Report Of The February 21, 2011 AC Meeting:

AGENDA
ARCHITECTURAL COMMISSION
RESCHEDULED REGULAR MEETING
Monday, February 21, 2011 at 7:00 P.M.

ITEM #2: For the ARCHITECTURAL COMMISSION on MONDAY, February 7, 2011 @ 7:00 P.M.

REQUEST: Consideration of a request for signage for "Exit Global Realty Pros", 238 Robert Parker Coffin Road within the B-1 Historic District, submitted by Sign-A-Rama on behalf of Dominick DiMaggio.

Southwest Corner of
Chester & Pheasant Run

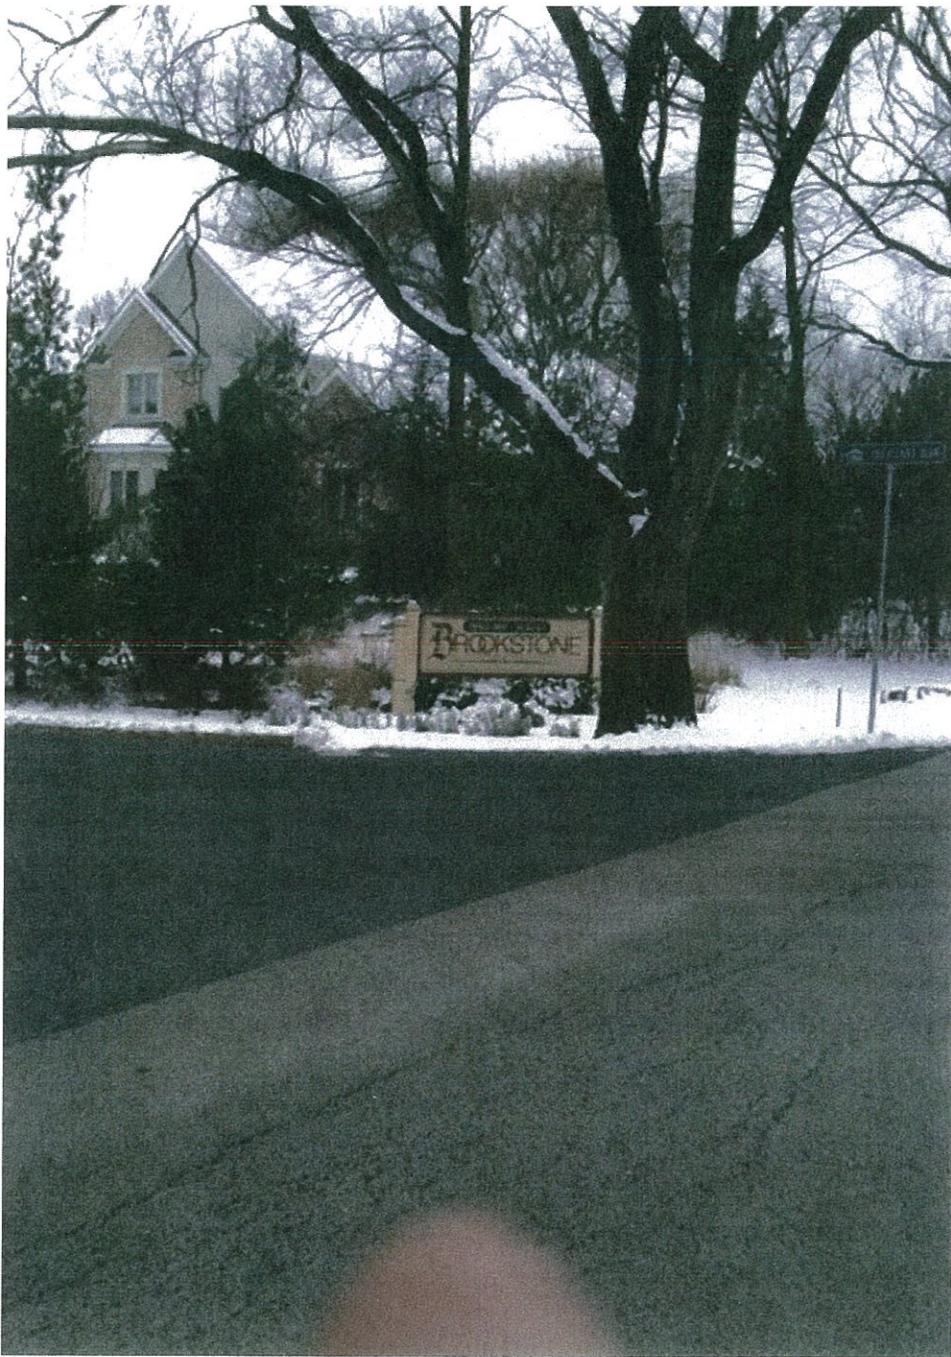
- *Consider reducing the size of the base to minimize any problems with settling which may occur once the sign is put in place.*
- *Be aware that any future illumination of the signage will require AC review and approval.*
- *Provide a detail on how the signage will be mounted to the base.*
- *Provide a site plan with the number & general location of the signs (a maximum of two signs not to exceed a total of 40 sq. feet; 20 sq. feet max. per sign in this case may be allowed).*
- *Have the font on the proposed signage remain consistent with the current & existing signage.*
- *Provide the dimensions of the area of the sign containing the "copy" (i.e. Brookstone).*

Based upon staff review of the proposal, each sign face would be single sided and measure (6' x 4') for approximately or approximately 24 square feet. The area of copy, and the area which is calculated for sign size is substantially less than that the area of the sign face. Based on the photographs submitted by the petitioner, it appears that both signs will not exceed 40 square feet in area (as defined in the Village Code) and will be in conformance with the Village Code. The copy will be black in color and affixed to the sign face. No illumination or additional landscaping is being proposed at this time.

The Board should review the request for signage in light of the aforementioned of regulations and render a determination based upon those criteria. As the actual dimensions of the copy area have not been submitted the AC may wish to consider a condition on any motion for approval which stipulates each sign may not exceed 20 square feet in area.

WEST ELEVATION - HISTORIC

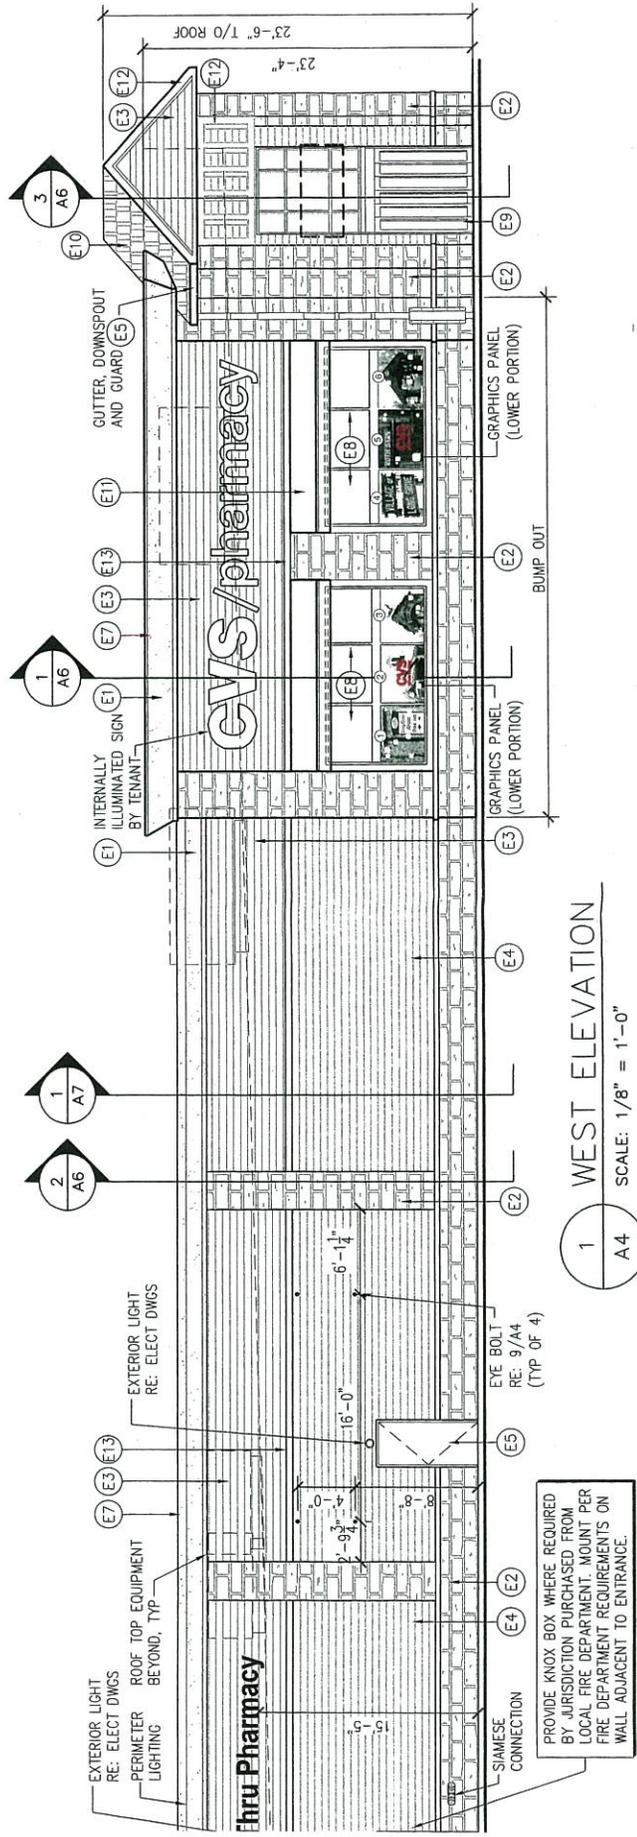
- Remove the red CVS logo from the window
- Remove the "teardrop" background
- Do not use "red" as a color in the window treatments
- The photos submitted are acceptable
